FW: Planning Consultation on: WA/39/26/DOC

Site Address: Longacres Eastergate Lane Walberton BN18 0BA

Description of Works: Approval of details reserved by condition imposed under WA/44/25/PL relating to conditions 3-surface water drainage and 4-discharge of flows to watercourses.

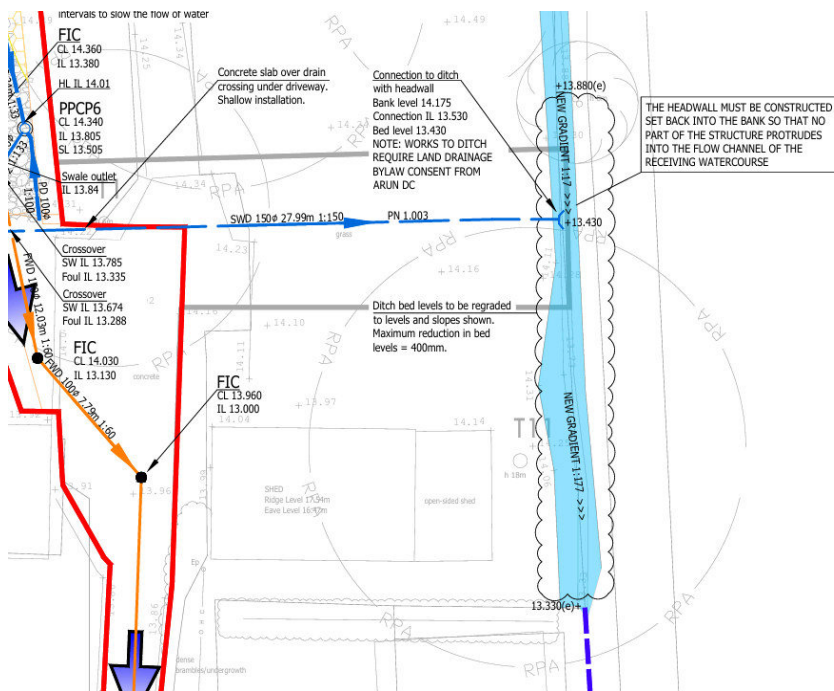
I am unclear which trees the Engineers have specific concerns with as it is a general comment, but as identified, it is clear to me that T11 would have been directly impacted. I would again, suggest that your Arboriculturist reviews the drainage plan, alongside the information concerning which trees are to be retained and those which are to be, or have been, removed, and provide a statement reviewing any impacts. If there are no longer any trees that would be impacted, a statement to this effect, alongside identification of which ones have been removed and why, would likely be sufficient.

The tree to the east of T10 also appears to be impacted along its margin. A point on this could be included within the statement.

Since this is a general comment from the Engineers, I would suggest you Arboriculturist reviews the drainage strategy proposed and comments on all trees that may be affected. However, the below is a snippet from your current drainage strategy. I think those directly impacted by levelling/excavation works within the ditch are the most crucial.

Just to provide an update: T11 was removed by the landowner last week for maintenance purposes, and the drainage works fall outside the RPA for T10. Our arborist is back this weekend, so we should be able to provide a formal comment next week. Knowing the specific tree of concern now will help us expedite the turnaround.
